AMENDMENT TO THE

REGIONAL WATER QUALITY MANAGEMENT PLAN

CITY OF WAUKESHA/ VILLAGE OF WALES

RESPONSE TO REQUESTS BY THE VILLAGE OF WALES AND THE CITY OF WAUKESHA TO AMEND THE WAUKESHA SANITARY SEWER SERVICE AREA

Map 1

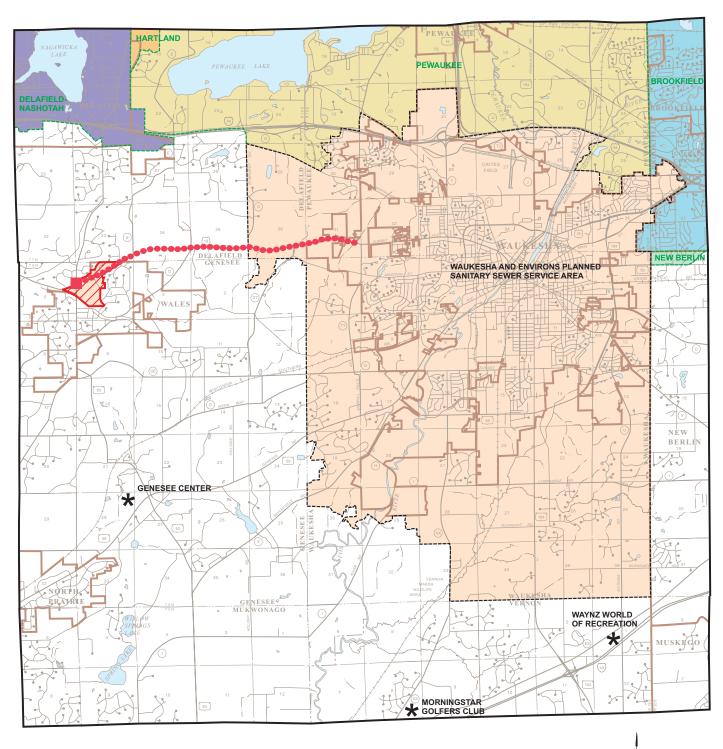
The portion of the Village of Wales that is proposed to be added to the Waukesha sewer service area includes 193 acres located in the vicinity of the intersection of STH 18 and STH 83 (see Map 1). Environmentally significant areas within the subject area consist of 2 acres of isolated natural resource area and 1 acre of small wetlands.

While detailed facility planning has not been completed, it is envisioned that wastewater from the subject area would be conveyed via a force main located generally along the STH 18 corridor, easterly to a connection point with Waukesha sewerage system near the intersection with Meadowbrook Road.

Based on the foregoing, it is recommended that the Southeastern Wisconsin Regional Planning Commission formally amend the sanitary sewer service area for the City of Waukesha as documented in SEWRPC Community Assistance Planning Report No. 100 (2nd Edition), as amended, in the manner identified on Map 1.
